# UNITED STATES PATENT AND TRADEMARK OFFICE

| APPLICATION NO.  | FILING DATE | FIRST NAMED INVENTOR | ATTORNEY DOCKET NO.  | CONFIRMATION NO. |
|--|-------------|----------------------|----------------------|------------------|
| 10/766,465   | 01/27/2004  | Ling Ma              | IR-2444 CIP (2-3869) | 3194             |

**Office Action Summary**

**DETAILED ACTION**

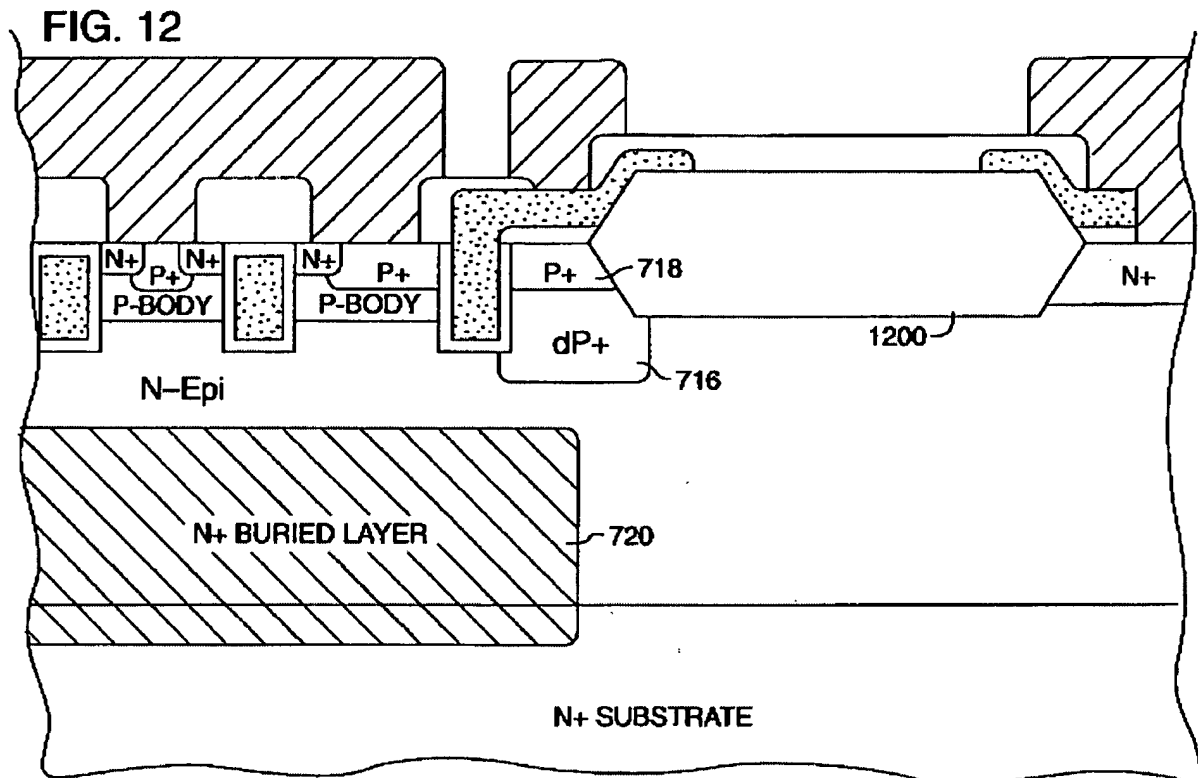
Claims 1, 7, & 8 are rejected under 35 U.S.C. 103(a) as being anticipated by Williams (US 5814858) in view of Zeng (US Pub 2003/0205758).

Williams discloses DC-DC converter as claimed. **See all the FIGS** where Williams teaches the following limitations

1. Pertaining claim 1, Williams discloses a DC-DC converter comprising:

a semiconductor body of a first conductivity **708** which includes a channel region **708** of a second conductivity **706** and a major surface;

an active region (**Fig. 11**) formed in said semiconductor body, said active region including a trench **702** extending through said channel region and a gate structure **702** disposed in said trench which includes a gate oxide layer **1102** (Column 7 lines 29-30) disposed at least on said sidewalls of said trench and a gate electrode **702** disposed adjacent said a gate oxide layer: and

a termination structure(**Fig. 12**), said termination structure including, a termination trench formed in said semiconductor body, and a field oxide layer formed in said termination trench below said major surface (**Fig 12**),

Williams fails to teach a field oxide layer formed in said termination trench below said major surface is thicker than said gate oxide layer. Zeng discloses a field oxide layer formed in said termination trench below said major surface (**Fig. 15 please note the element 340 (Oxide layer) is thicker than the gate oxide layer 40**). In view of Zeng, it would have been obvious to one of ordinary skill in the art to incorporate the process step of Zeng into the Williams because "the power MOSFETs used in power management circuitry can be efficiently turned on and off at low gate drive voltage" (column 1 paragraph[0002] lines 8-10).

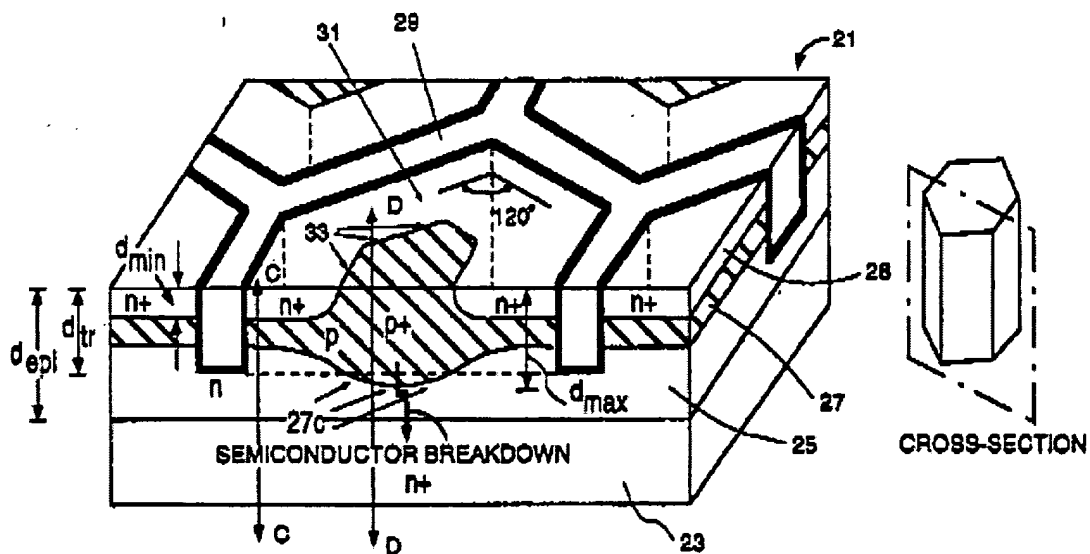
Claims 4- 6 are rejected under 35 U.S.C. 103(a) as being anticipated by Williams (US 5814858) in view of Zeng (US Pub 2003/0205758) and further in view of Aoki et al. (US Pub 2002/0167046).

4. Pertaining claim 4, Williams in view of Zeng fails to teach trench including an oxide mass formed at its bottom said oxide mass being thicker than said gate oxide layer. Aoki discloses trench including an oxide mass formed at its bottom said oxide mass being thicker than said gate oxide layer (**Paragraph [0045] element 7e**). In view of Aoki, it would have been obvious to one of ordinary skill in the art to incorporate the trench of Aoki into Williams in view of Zeng because of "lower withstand voltage" (**paragraph [0005]**)

5. Pertaining claim 5, Williams in view of Zeng discloses a semiconductor device according to claim 4, wherein said semiconductor body includes conductive regions **706** of said first conductivity formed adjacent said trench in said channel region **708**, and further comprising a semiconductor substrate of said conductivity **714**, said semiconductor body being formed over said semiconductor substrate, wherein said conductive regions are electrically connectable to said semiconductor substrate through invertible channels adjacent said trench (**Fig. 11H, Please note the power MOSFET**

has conductive regions 706, which are electrically connectable to semiconductor substrate through invertible channels).

6. Pertaining claim 6, Williams in view of Zeng discloses a semiconductor device according to claim 5, wherein said conductive regions are source regions **706**.
